UNITED STATES PATENT AND TRADEMARK OFFICE

APPLICATION NO.	FILING DATE	FIRST NAMED INVENTOR	ATTORNEY DOCKET NO.	CONFIRMATION NO.
10/046,285	01/16/2002	Jae Sung Kim	RPL-0025	2364

Office Action Summary	Application N .		Applicant(s)	
	10/046,285		KIM ET AL.	
	Examiner		Art Unit	
	Tuyet Vo		2821

DETAILED ACTION

Fig. 4

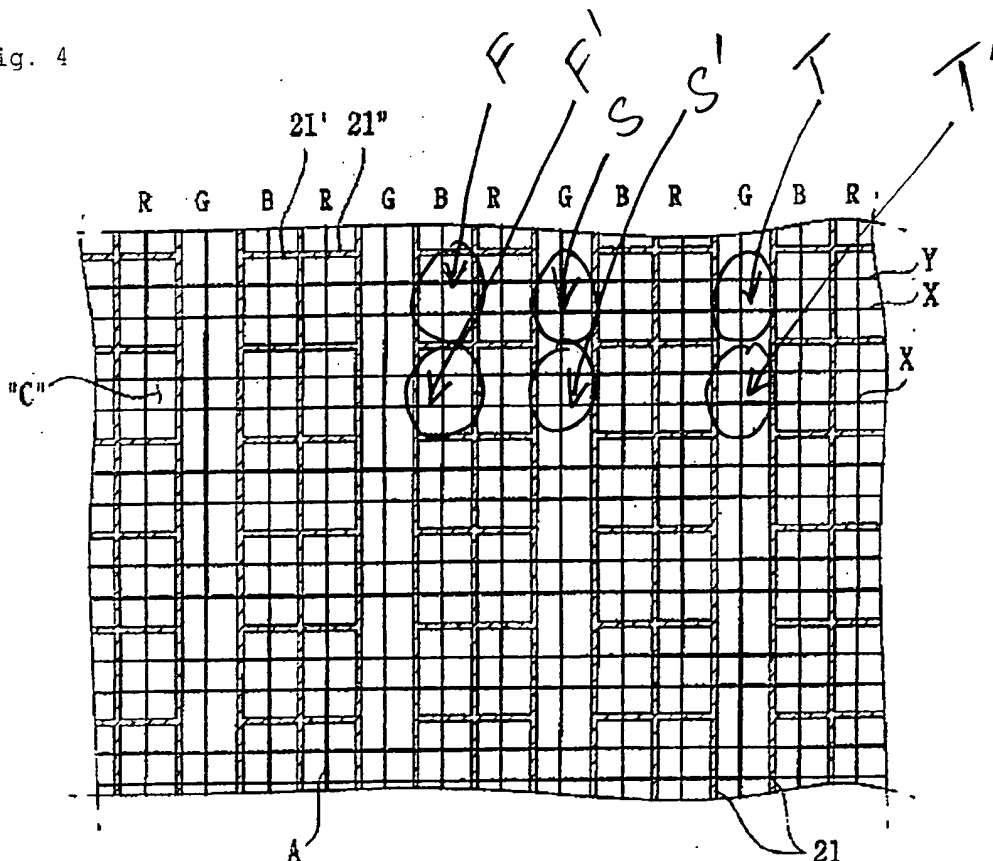
Regarding claims 9-11, the admitted prior art shown in figure 4 clearly discloses plasma display device comprising:

three sets of discharge cells are separated by barriers;

each cell of first blue discharge cells (F, marked by examiner) is separated from another adjacent cell of the first blue discharge cells (F', marked by examiner);

each cell of second set of discharge cells (S, marked by examiner) is separated from another adjacent cell of the second discharge cells (S', marked by examiner); and

each cell of third set of discharge cells (T, marked by examiner) is separated from another adjacent cell of the first blue discharge cell (T', marked by examiner).
